WIND ENERGY FACILITY NOISE AUDIT PROTOCOL

Facility Alberton Wind Energy Facility

Evidence Alberton Wind Farm Pre Construction Noise Assessment, Marshall Day Acoustics, 19 April 2018

Figure 1: Guaranteed sound power level vs. hub height wind speed

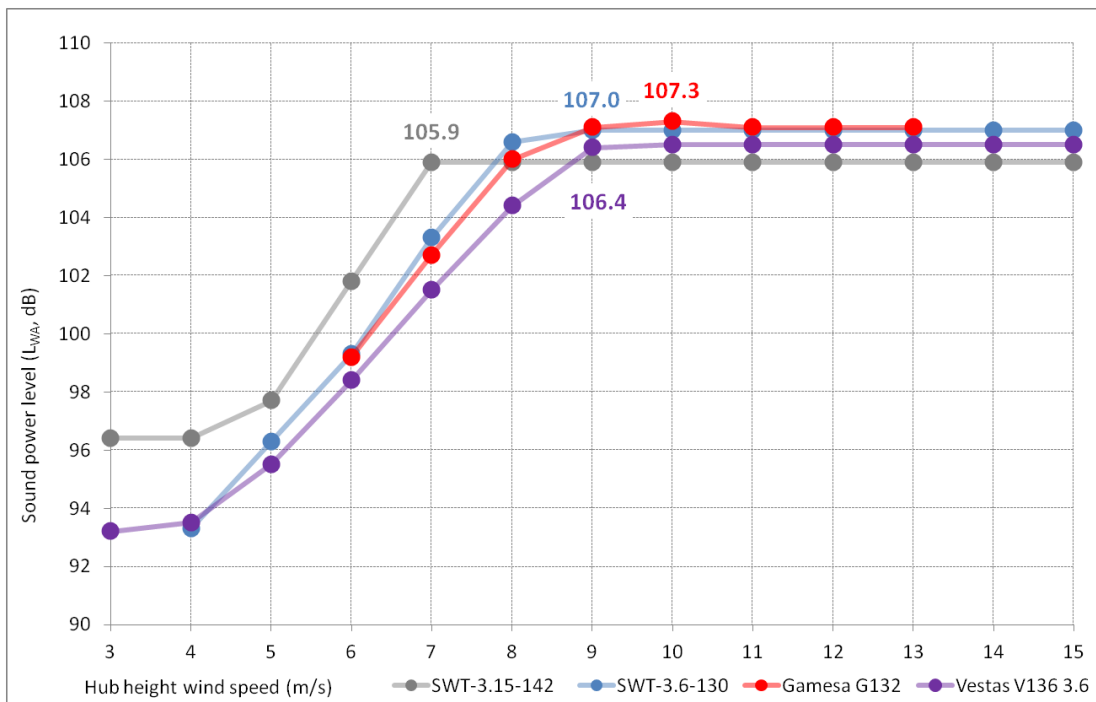
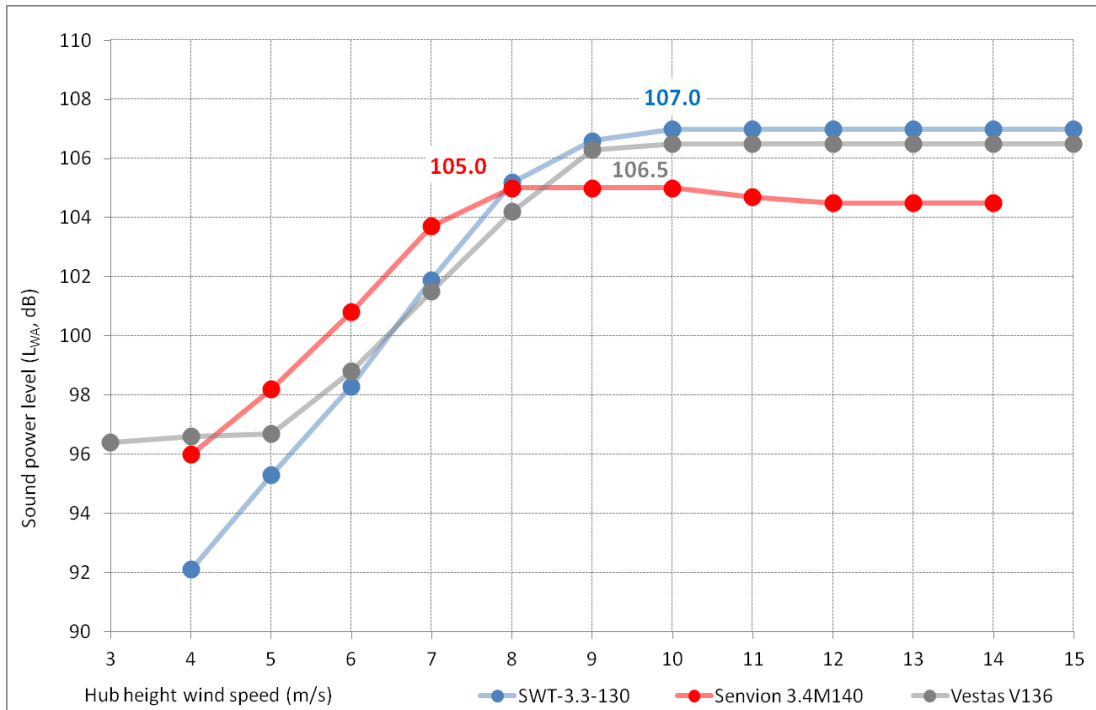
Section	Requirements relevant to the Audit	Comply	Observations/ Comments
Definitions	Measurement time: 10min accuracy 1% ie 6 secs Noise Limit: not to be exceeded Notional Boundary: A line 20m from any side of a noise sensitive location Post-installation sound level: A weighted L90 centile level i.e dB L90(10min) Cut in speed typical: 4 m per sec. Shut down 25 m per sec		Cut in wind speed is provided in Figures as down to 3m/s. Shut down is not specified. Maximum sound power is reached by 11 m/s for all candidate turbines (ref Figure 1 MDA, 2018).
